Well Name: POKER LAKE UNIT 21 DTD	Well Location: T24S / R30E / SEC 21 / SWNE / 32.207388 / -103.882201	County or Parish/State: EDDY / NM
Well Number: 175H	Type of Well: CONVENTIONAL GAS WELL	Allottee or Tribe Name:
Lease Number: NMLC068431	Unit or CA Name: POKER LAKE UNIT	Unit or CA Number: NMNM71016X
US Well Number: 3001550185	Operator: XTO PERMIAN OPERATING LLC

Notice of Intent

Sundry ID: 2870319

XTO Permian Operating LLC respectfully requests to make the following changes for:

ACREAGE DEDICATION PLATS

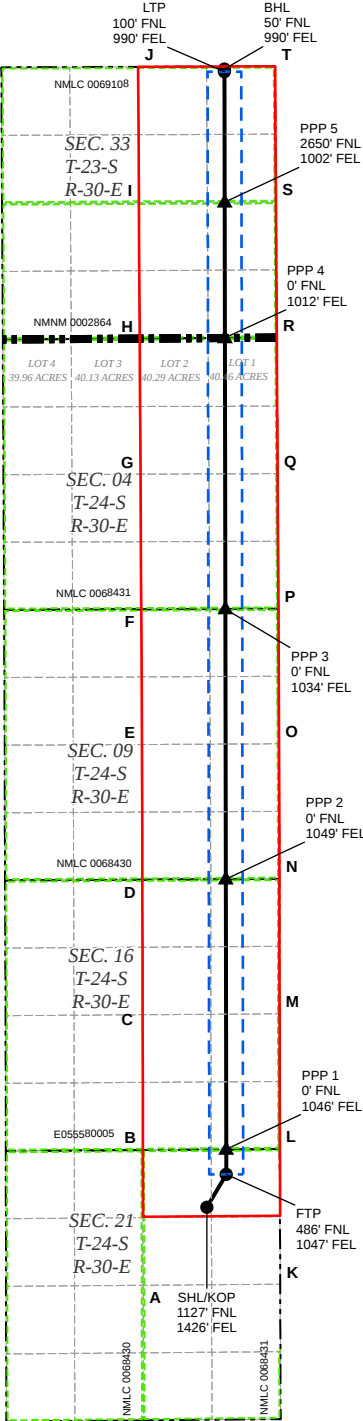
Dedicated acres: f/ 640.46 t/ 1360.75

TD: f/ 32898' MD / 10938' TVD t/ 32373 MD/ 10849.5 TVD

FTP: f/ 100 FSL & 1430 FEL t/ 486 FNL & 1047 FEL, Sec 21-24S-30E; Lease NMLC 0068431

Updated HSU
